SUBJECT: Responds to NRC 870602 request for addl info re use of Boraflex in high density spent fuel storage racks. Existence of small horizontal gaps in Boraflex poison matl discussed.

Re: Docket No. 50-275, OL-DPR-80
Docket No. 50-323, OL-DPR-82
Diablo Canyon Units 1 and 2
Use of Boraflex in Spent Fuel Storage Racks

PGandE RESPONSES TO NRC QUESTIONS ON THE USE OF BORAFLEX IN SPENT FUEL STORAGE RACKS

**FIGURE 1 3 x 3 Typical Array
 (Poisoned Cells)**

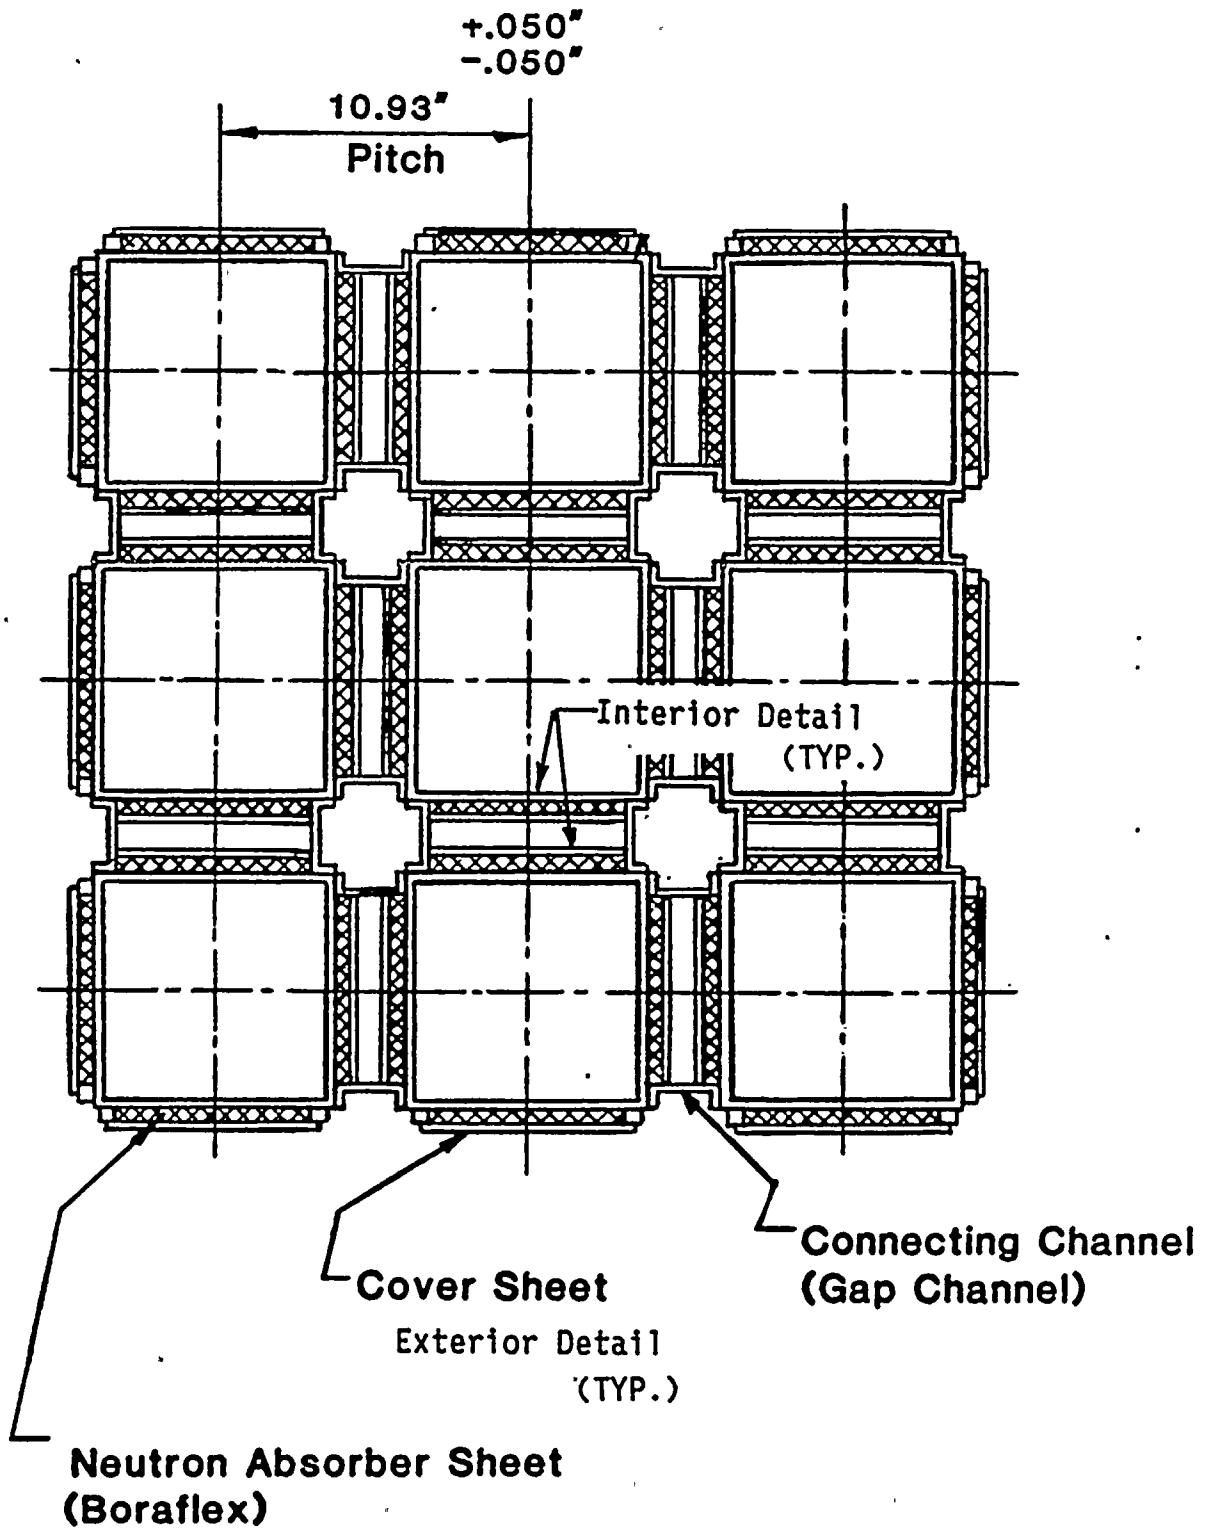
Based on the recent experience pertaining to degradation of Boraflex in spent fuel pools at Quad Cities and Point Beach nuclear power plants, provide justification to demonstrate the continued acceptability of Boraflex for application in the Diablo Canyon spent fuel pool.

In contrast, the Boraflex sheets used at DCPD are not clamped tightly but are supported by stainless steel cover plates on the outside faces of the cell walls, as shown in Figures 1 and 2. More important, on all interior rack walls, spot welds (through cutouts in the Boraflex) at 12-inch intervals are used to hold the backing plate in place, as shown in Figure 2. By pinning the Boraflex in place, these spot welds effectively prevent formation of large gaps from the shrinkage of Boraflex. Small gaps might form, which would not lead to an increase in reactivity above the acceptable limit ($k_{eff} \leq 0.95$, as specified in NRC guidelines).
